**CITY OF GRANT  
PLANNING COMMISSION MEETING**

Tuesday, January 17, 2017

Application for Minor Subdivision  
10450 Dellwood Road

**Re:** 2017 Mahtomedi Public Schools Pavement Reconstruction Plan - Engineering Review

PARCEL LINE  
ADJUSTMENT

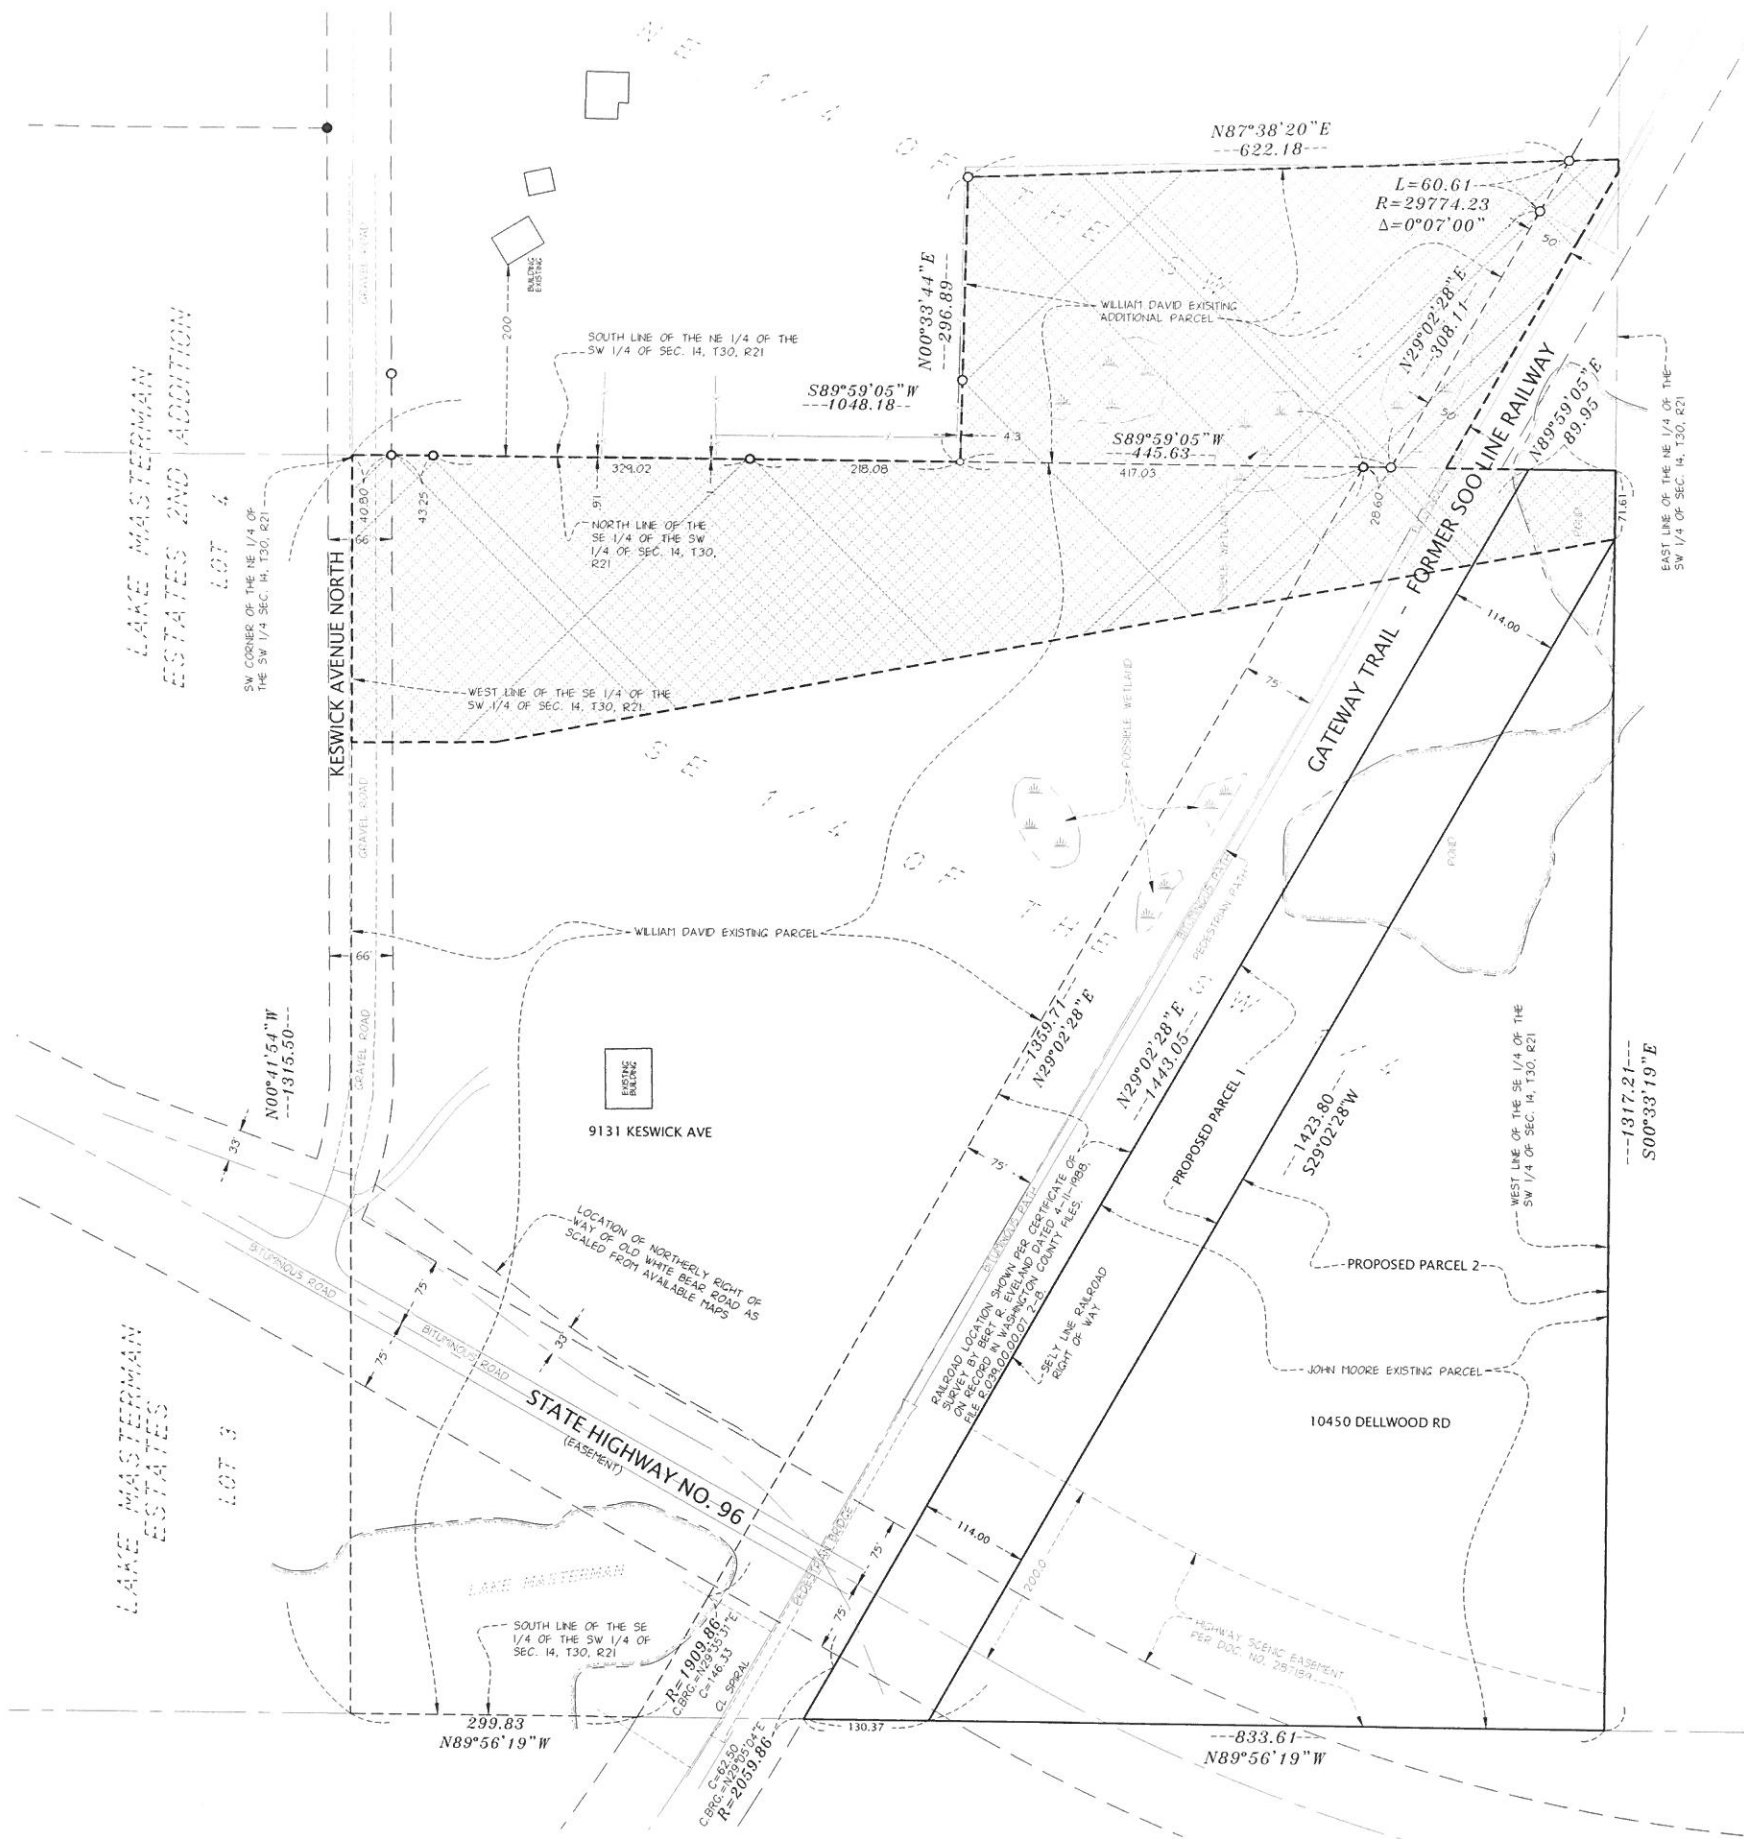
The survey submitted is attached as Figure 1, and is titled "Parcel Line Adjustment" dated 12/16/16. On the figure, there is an area identified as "PROPOSED FUTURE PARCEL" which includes portions of PID 1403021340003 and all of PID 1403021310008. This proposed parcel is not legally described, and the parcel area and dimensions are not provided. While it is helpful to know the future intentions of the Applicant, this review does not consider the proposed parcel or evaluate it for compliance with the City's Zoning Ordinance and dimensional standards because it is Staff's understanding that the Applicant is NOT requesting formal subdivision approval of this parcel. *Therefore, staff would recommend including a condition that specifically states that the area denoted as "PROPOSED FUTURE PARCEL" is not a legal parcel, and that this subdivision review process has not determined whether this area meets the current zoning or comprehensive plan standards. Any future subdivision of this area will be subject to rules and regulations in place at the time of the Application.*

- Staff would recommend approval of the lot line rearrangement and combination with the following findings:
- Proposed Parcel 1 is permitted to obtain an individual PID after subdivision, and is not required to be combined with PID 1403021340003, because it is non-contiguous to PID 1403021340003 due to the existence of the Gateway Trail.
  - The proposed subdivision does not negatively impact the public health, safety or welfare of the adjacent neighborhood or larger community.
  - The proposed subdivision is consistent with the City’s adopted Comprehensive Plan.
  - The proposed subdivision does not create a new buildable lot, and does not propose an increase in density.
  - Portions of the minor subdivision code are not applicable because the created parcel is deemed non-buildable and will be considered as part of PID 1403021340003 for purposes of zoning and land use.
